Concept Approval

MP10_0165

Project:

Residential flat development concept, including:

Figure 1: Revised Building Envelope- Building A

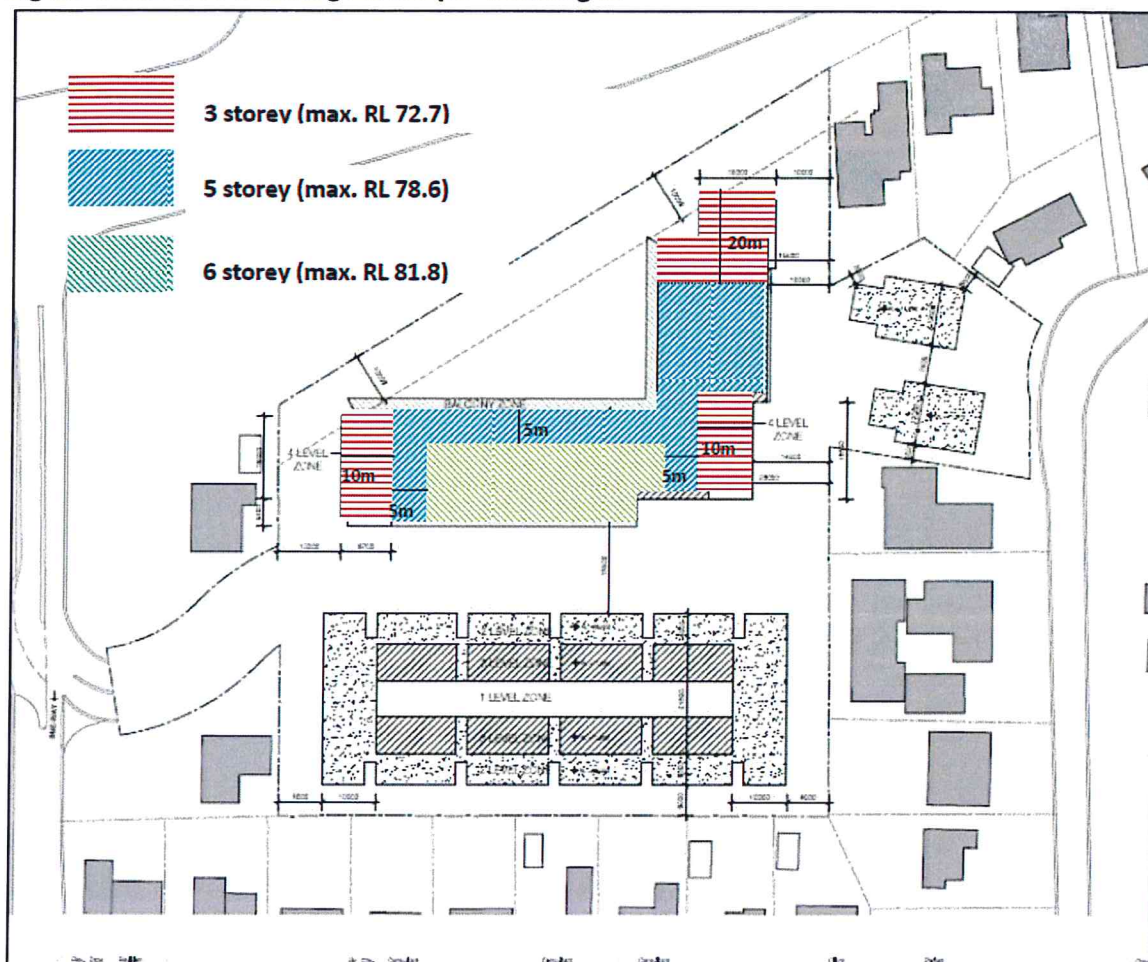
The building heights shown on 'Envelope Plan' DA-04 prepared by SJB Architects and referred to in condition A2 shall be modified as follows:

- a) the building envelope for Building A (fronting Epping Road) shall be reduced to 3, 5 and 6 storeys (maximum RLs 72.2m, 78.6m and 81.8m, respectively) as illustrated in **Figure 1** below, excluding any plant, lift overruns, or similar projections). Drawings indicating heights to AHD shall be provided with the future application/s.
